Cory Decarbonisation Project

Written Representation on behalf of Landsul Limited and Munster Joinery (U.K.) Limited

Introduction

Figure 1 – Indicative Equipment Layout from DCO

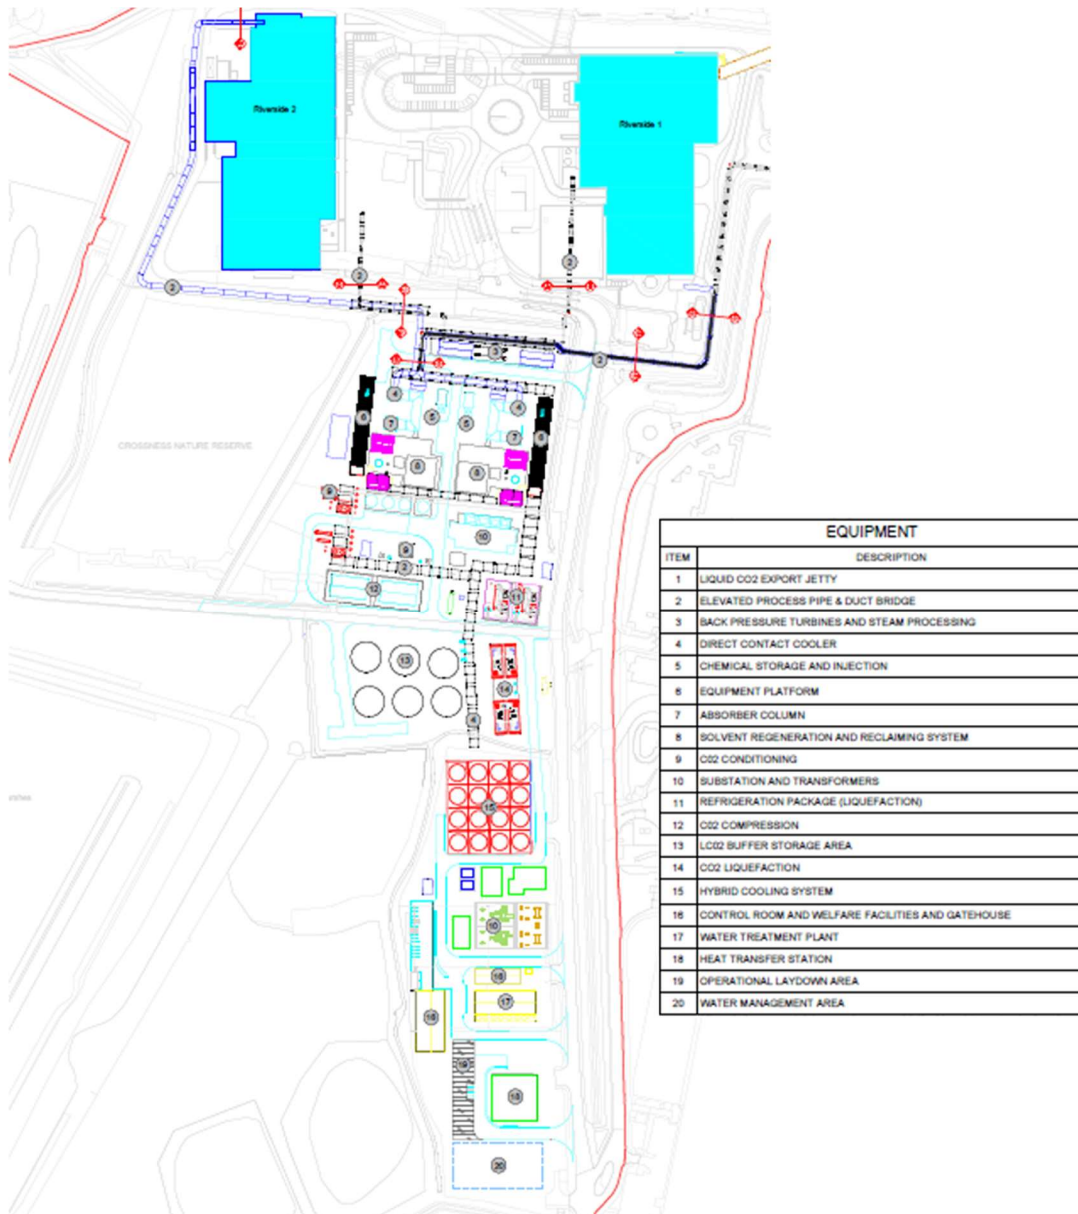
- 2.6 The equipment selected is generally typical of what would be expected for a facility to capture, liquefy and store CO₂. However, as I will explain in the following sections, there are some items of equipment that appear unnecessary and this, combined with some of the design assumptions, has led to a site footprint that is considerably larger than required.

Figure 2 - Footprint comparison (2 line vs 1 line)

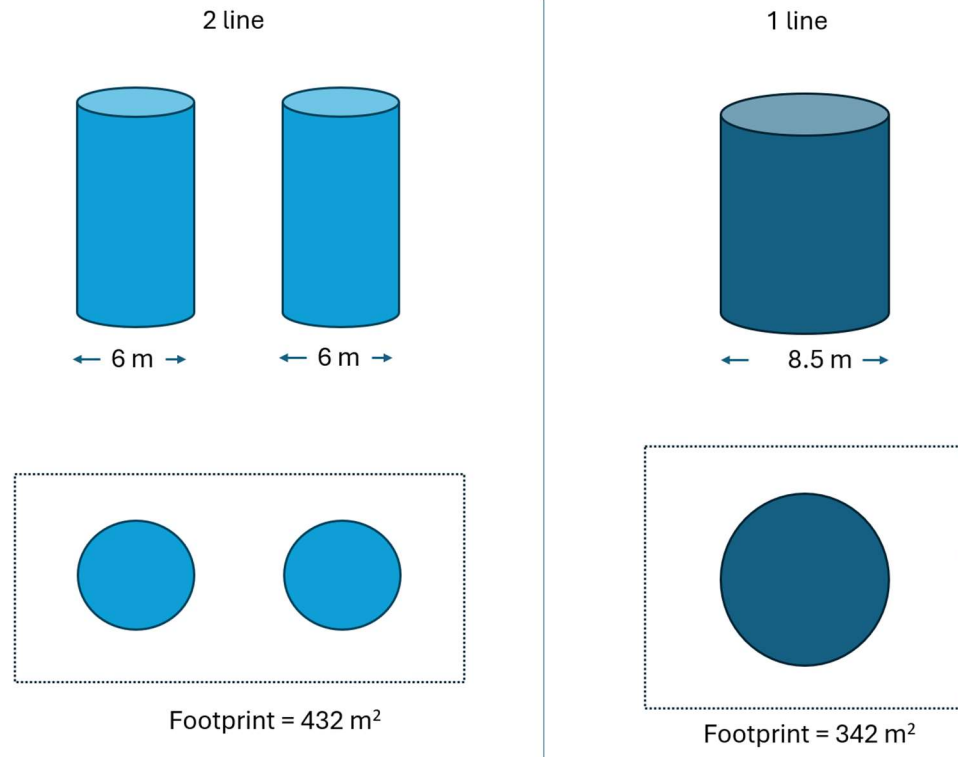
- 2.14 Finally, and most significantly, the overall site footprint is dictated not just by the process equipment itself but the need to provide access for operation and maintenance. Therefore, doubling the quantity of equipment also significantly increases the space that is required to permit operation and maintenance. This is illustrated by the simple sketch below which shows a 2 line plant utilising 2 x 6m diameter columns and the equivalent 1 line plant which would require a 8.5m diameter column to maintain the same column cross sectional area. For the sake of illustration, I have kept the height the same although (as per paragraph 2.13) this is not a hard constraint. For both, a 5m buffer around the units has been provided for maintenance. It can be seen that the footprint for the 1 line plant is 342 m² whilst the footprint for the 2 line plant is 432 m² (26% more).

- 2.15 It can be seen that the decision to adopt a two-line approach is not neutral in terms of footprint as the Applicant suggests. Rather, selecting a two-line approach will significantly increase the required footprint.

Figure 3 - "Substation and Transformers" equipment item from DCO application

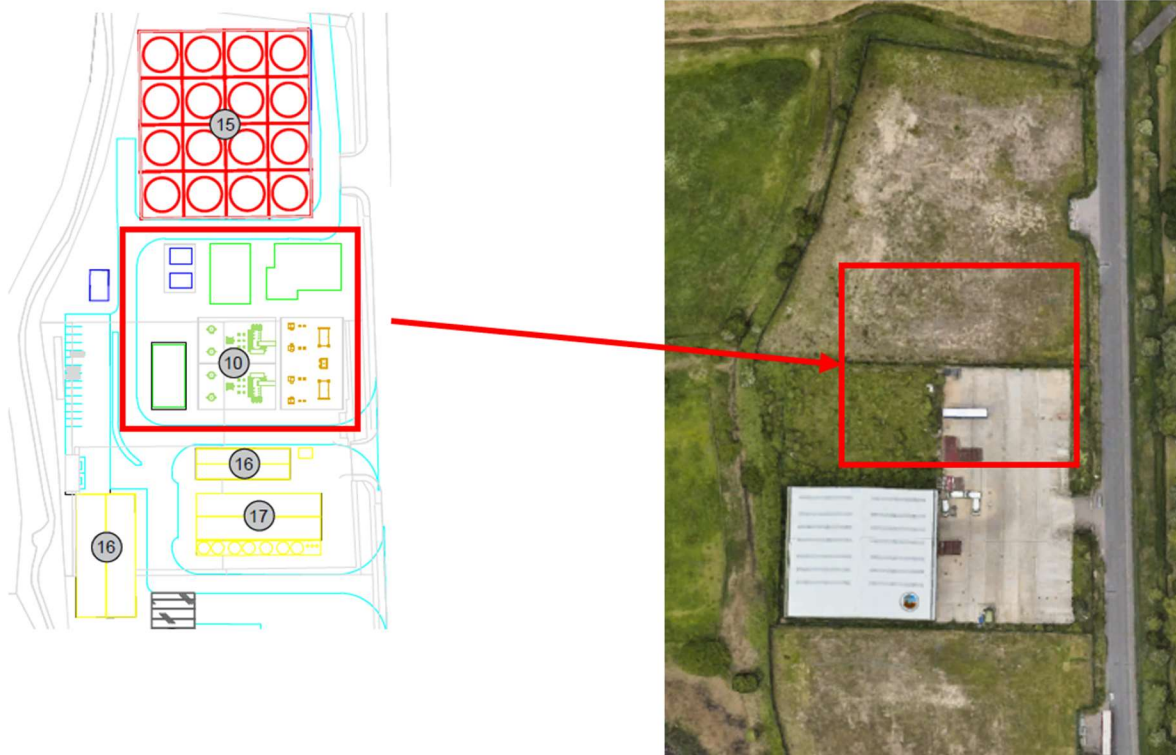
- 2.19 However, despite these arrangements the Applicant has also included a separate switchyard (item 10). This is shown in the diagram along with the approximate location on a satellite image from Google Earth.

- 2.20 Substation and transformer plant is used to provide appropriate isolations, metering and voltage step-up / step-down to connect facilities to electricity supplies on distribution and transmission electrical networks. In short, they enable electricity to be either imported or exported from a site. However, given that the Applicant proposes to serve the electrical needs of the development through a connection to the existing Riverside 1 and 2 facilities plus self-generation through a back-pressure steam turbine generator unit the need for this substation and transformer plant is not apparent.

- 2.21 The area of the red box in figure 3 is approximately 0.4 hectares (4,000 m²). This is equivalent to about half of the Munster Joinery Land.

Figure 5 - Liquefaction and Storage (items 11, 13 and 14)

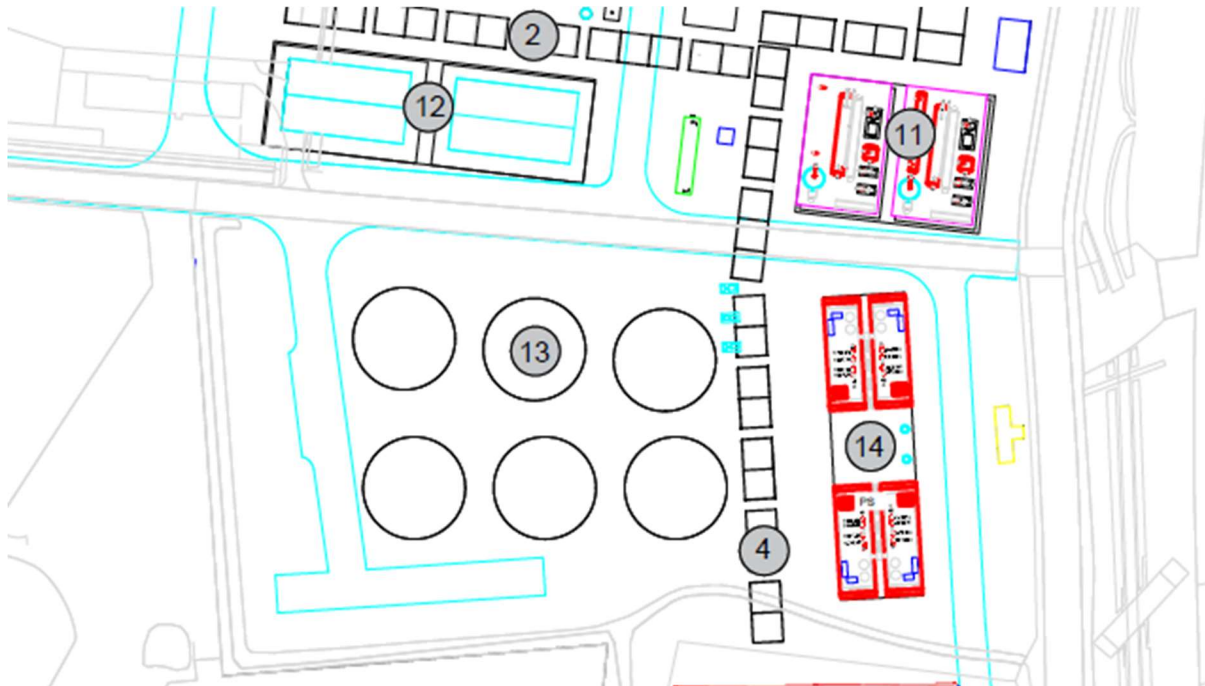
- 2.26 In terms of the main process equipment associated with the compression and liquefaction the footprint suggested by the Applicant appears generally reasonable.
- 2.27 However, the site footprint though is not just driven by the equipment itself, it is necessary to provide adequate space to permit access for operations and maintenance and it is a general feature of the Applicant's site layout that the space around equipment / areas of unused / wasted space are excessive. This can be clearly seen when considering the liquefaction and storage as illustrated in Figure 5.

- 2.28 The area of land occupied by the liquefaction and storage is approximately 11,250 m². However, it can be seen from Figure 5 that the actual process equipment occupies less than half of this. As I discuss in 3.8 to 3.9 it is possible to accommodate liquefaction and storage equipment that will achieve the required duty in a much reduced space without compromising operability and maintainability.

Figure 6- Heat transfer station and operational laydown area

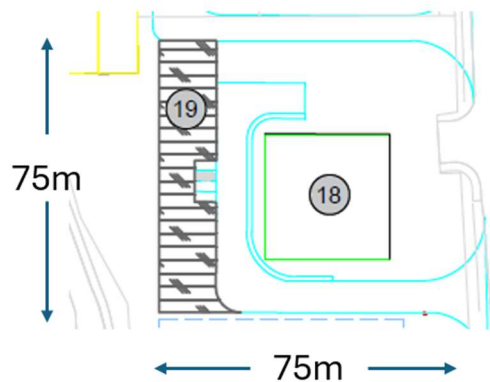
- 2.48 A feature of the Applicant's layout is the significant space that is allowed around items of equipment and a failure to best optimise the footprint available. The heat transfer station is an example of this as can be seen from Figure 6 below. The heat transfer station is designated 18 whilst area 19 is designated for operational laydown. It can be seen that the heat transfer station is surrounded by roads and hardstanding meaning that the building itself occupies only about 25% of the available area to the east of the operational laydown area. Access to the operational laydown area is achieved from a road running between that area and the heat transfer station ignoring the potential to use the area to the west of the operational laydown area for access which means that area is effectively unused.

- 2.49 As shown in Figure 6 the Applicant has configured the site such that there is an area allocated for operational laydown. Operational laydown, in relatively close proximity to the plant is certainly beneficial – particularly during outages. However, there is no absolute requirement that this be on the carbon capture site itself – it could be located within the wider Riverside campus. It would appear that there is plenty of other alternative land available to the Applicant for temporary laydown on the existing EfW facilities as shown in the image from Google Earth below.

Figure 11 - Options considered by the Applicant

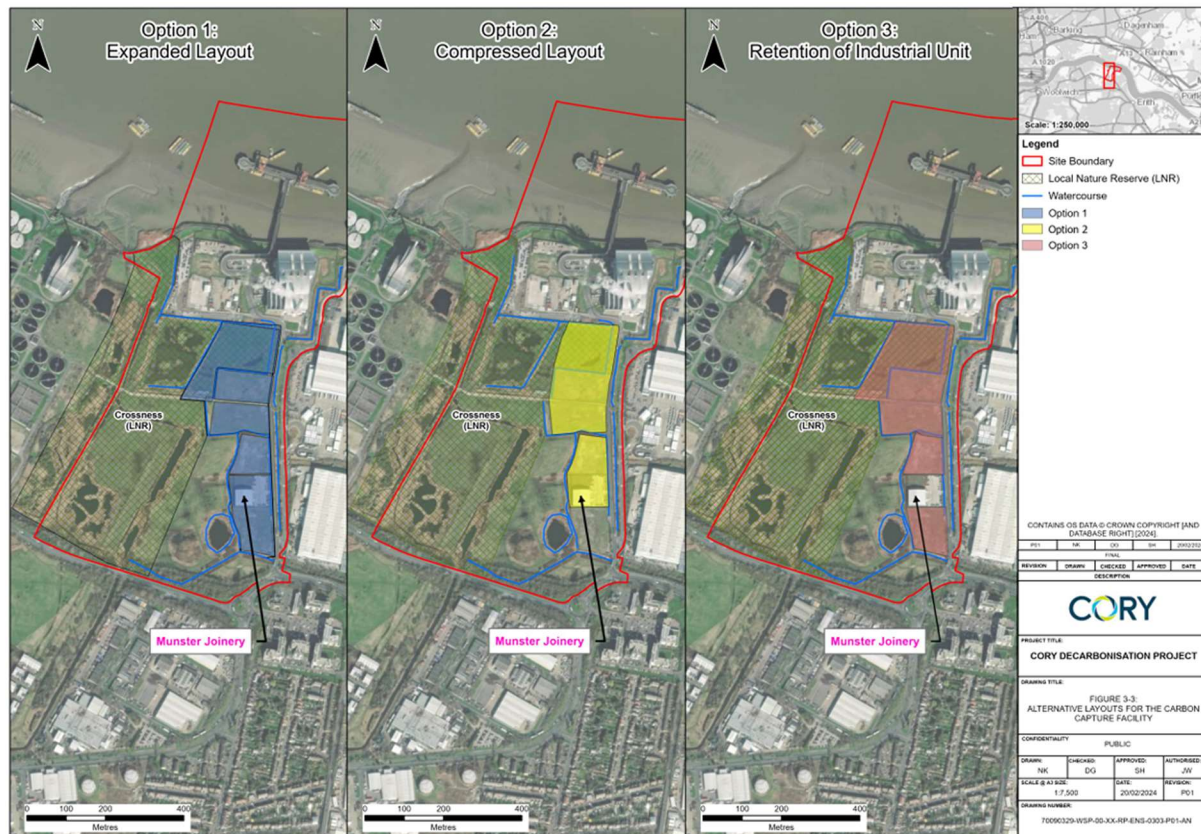
4.2 The Applicant states the required footprint to be approximately 8 hectares (80,000 m²)^[16]. As shown in Figure 11 the Applicant provides a footprint^[19] for three different potential layouts.

- 4.3 As a comparison, I have measured the total footprints of the Applicant's options and my alternative layout using Google Earth. The comparative approximate footprints are:
- (a) Applicant's Option 1 (Expanded) = 74,000 m²
 - (b) Applicant's Option 2 (Compressed) = 55,000 m²
 - (c) Applicant's Option 3 (Retention of Industrial Unit) = 66,000 m²
 - (d) Alternative Site Layout = 46,000 m²
- 4.4 However, at the Issue Specific Hearing on 6th November 2024, the Applicant presented an amended version of the above plot plans and clarified that the shading on option 2 was incorrect in the original footprint which I have replicated as Figure 11 above. The amended footprint for option 2 is replicated below in Figure 12. My measurement using Google Earth for this footprint was approximately 61,000 m².

Figure 13- Footprint reduction opportunities

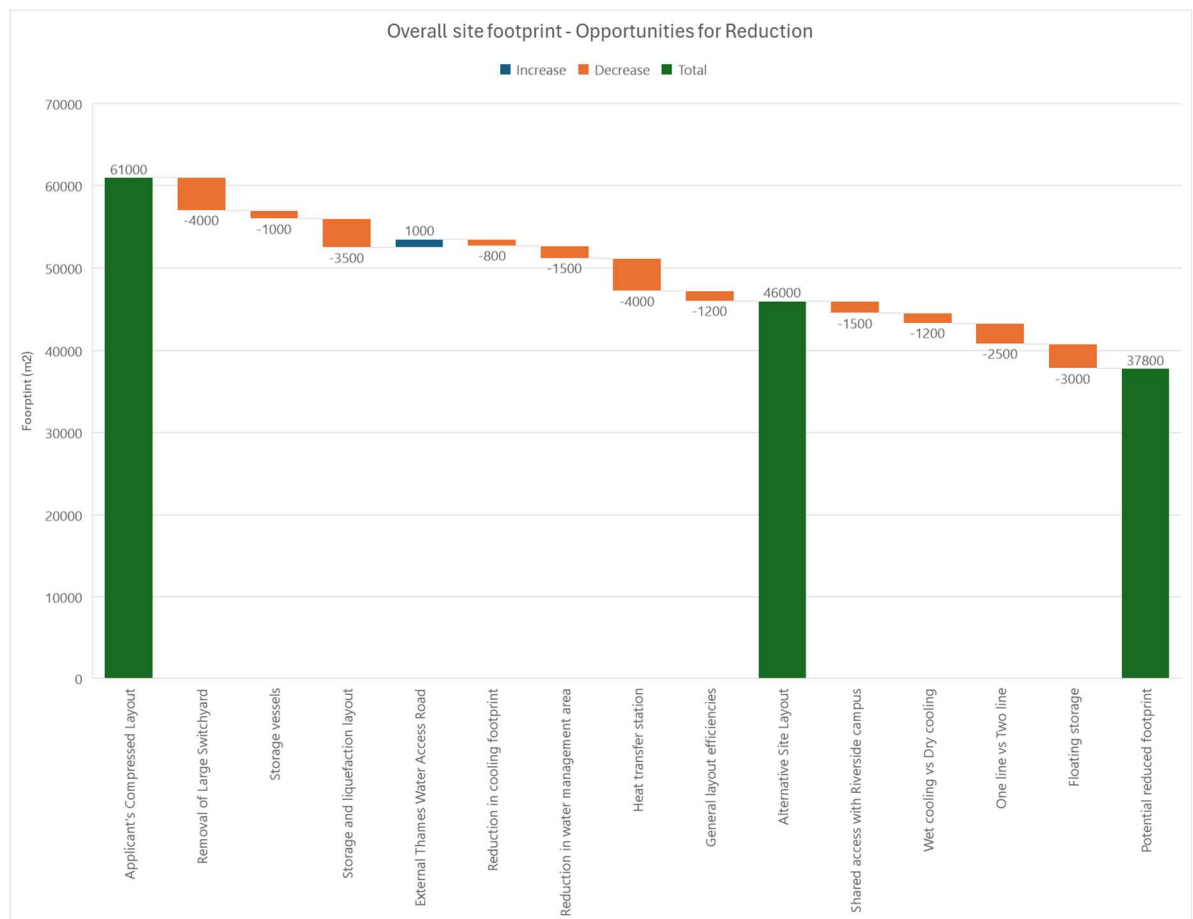
- 4.7 In addition to the savings identified in the Alternative Layout, the waterfall chart also makes some estimates on additional savings that might be attainable if different design assumptions / decisions were taken.

- 4.8 As can be seen from Figure 13, one area of footprint saving is simply being more efficient with the specific location / position of plant items and supporting infrastructure (in particular for the liquefaction and storage plant). This is partly due to the shape of the land for the development. For the southern part especially, it is not a rectangle / square which makes it harder to fully utilise the land available in that part of the site. Further, given that provision of access around plant and equipment is a significant driver of required footprint, reduction in equipment sizing (for instance the CO₂ storage vessels) also enables a reduction in footprint for access.

Figure 17- North 1 Zone available footprint

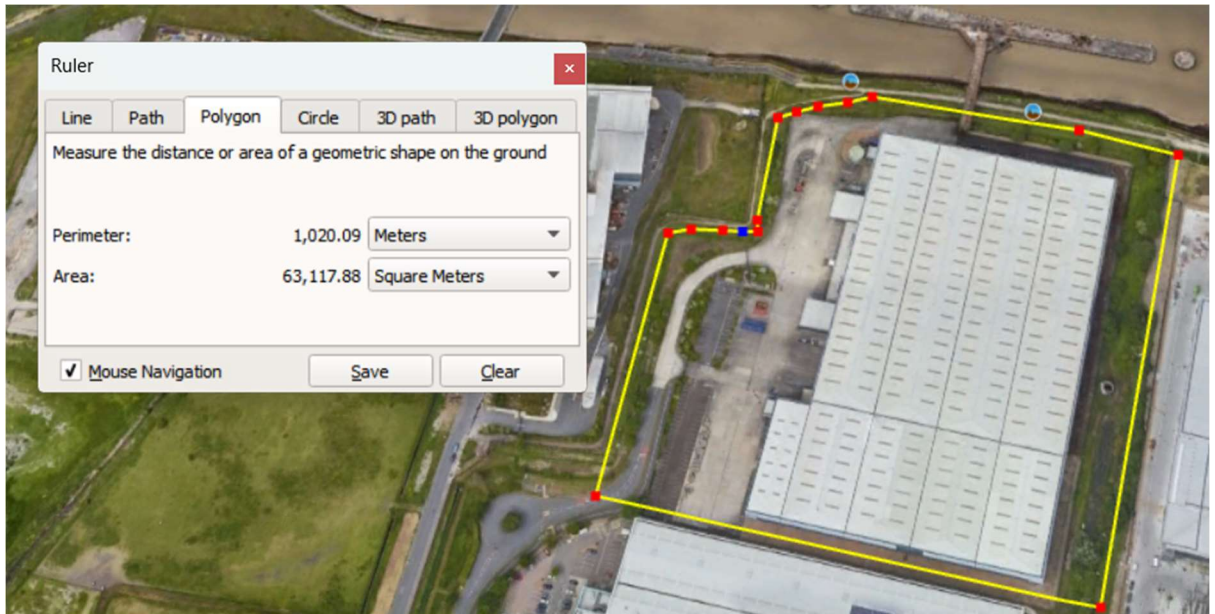
- 4.18 I would also note that in terms of business impact, the area that is actually required for the development is very much smaller than the East zone considered. As shown in Figure 17 below, the terrestrial part of the area now designated as North 1 by the Applicant is sufficiently large to accommodate the full carbon capture development even using the 61,000 m² footprint of the Applicant’s own proposed scheme. The result of this is that there would be no impact on the Lidl operation as assumed in the assessment of the East Zone in the Terrestrial Site Alternatives Report.
